The application circuit for Figure 19, the 100W Audio Amplifier, of the **LT[®]1166** data sheet has two corrections as indicated below. For complete specifications, typical performance characteristics and applications information, please see the **LT1166** data sheet.

The Corrected Schematic:

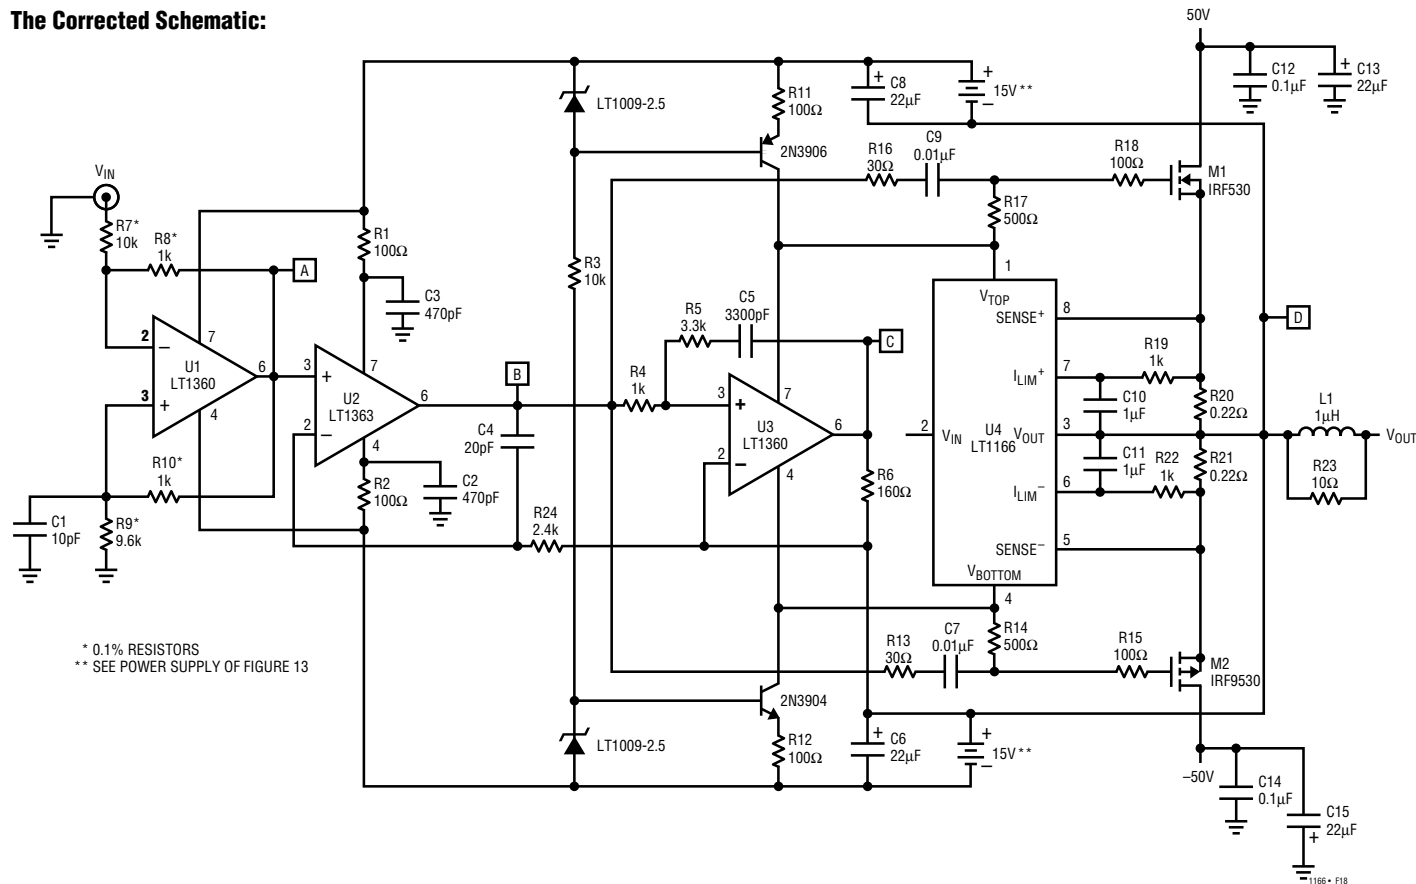
Changes Made in the Schematic:

- 1) U1, LT1360: changed Pin 3 to Pin 2; changed Pin 2 to Pin 3
- 2) U3, LT1360: changed + sign to – sign; changed – sign to + sign
